**Re: Environmental Impact Study & Restoration Plan Addendum Letter
WJ Canada
1565 County Road 18, Lakefield, Township of Selwyn
D.M. Wills Associates Project No. 11230-01**

Figure 1 - Restoration Area

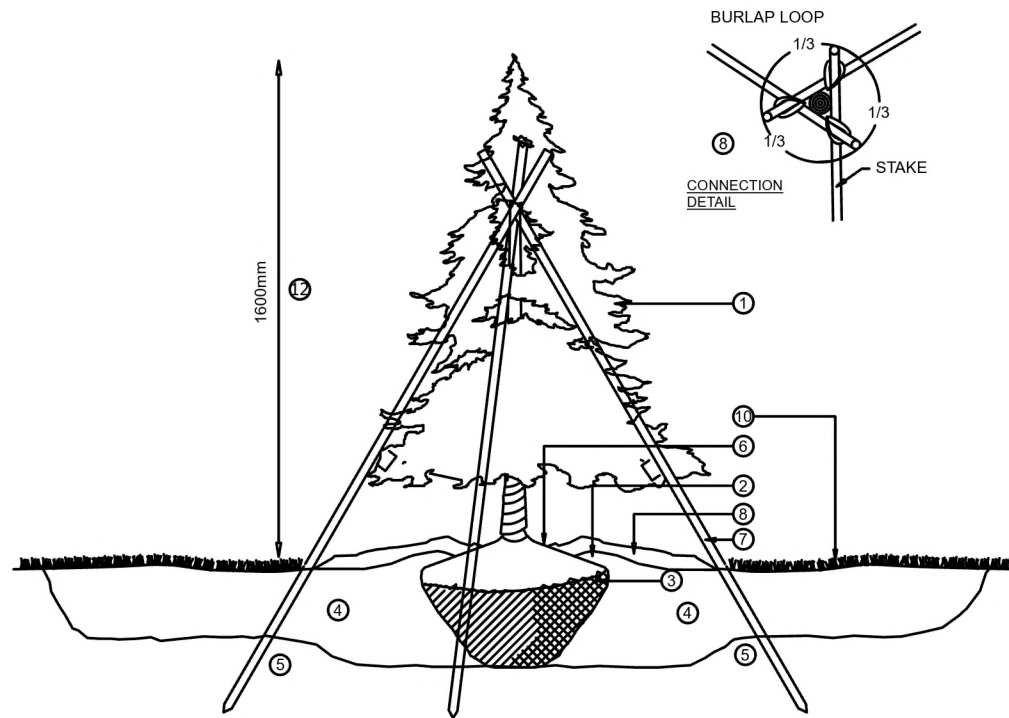
As the footprint of the revised Site Plan has not changed, the overall size of the restoration area remains largely unchanged. However, an updated restoration plan, as outlined in **Figure 1**, is recommended to better achieve the objectives of the Restoration Plan.

In addition to the details presented in **Figure 1**, it is recommended to install a gated chain-link fence along the northern boundary of the restoration area, as shown in **Figure 1**, to prevent entrance and inadvertent damage. The fence will contribute to the long-term protection of the restoration area and to prevent accidental impacts associated with the proposed change in land use.
